POLICY REPORT
DEVELOPMENT AND BUILDING

Report Date: May 2, 2017
Contact: Susan Haid
Contact No.: 604.871.6431
RTS No.: 12023
VanRIMS No.: 08-2000-20
Meeting Date: May 16, 2017

TO: Vancouver City Council
FROM: General Manager of Planning, Urban Design and Sustainability
SUBJECT: CD-1 Rezoning: 469-485 West 59th Avenue

Figure 4 - Site Plan

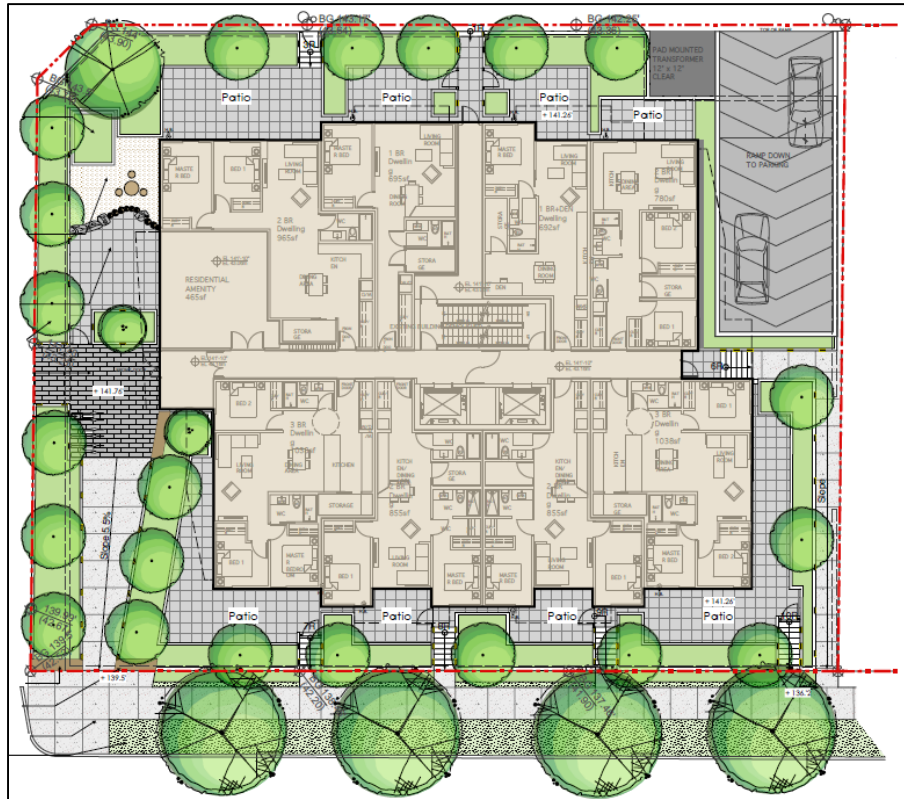
The overall building width modestly exceeds the maximum guideline width of 100 ft. However, the building configuration responds well by shifting the massing in the east-west direction, such that only 100 ft. of width faces the street. Staff are satisfied that this solution meets the intent of the building width parameter.

The proposal is generally consistent with the height and built form guidelines set out in the MCP. Staff are supportive of the proposed form of development subject to conditions outlined in Appendix B, which include provision of improvements to the ground plane grading, the configuration of the outdoor amenity space and reduction in overlook impacts.

- 1. Design development to provide clearly identifiable pedestrian access to the building's main entry from 59th Avenue.
- 2. Design development to reduce apparent building bulk and reduce potential overlook by reducing the length of balconies on level six.

- 3. Design development to reduce overlook impacts from level five balconies.
- 4. Design development to each building façade to address and respond to the specific orientation and urban condition that it faces.

- 7. Design development to improve the configuration of the outdoor amenity area.
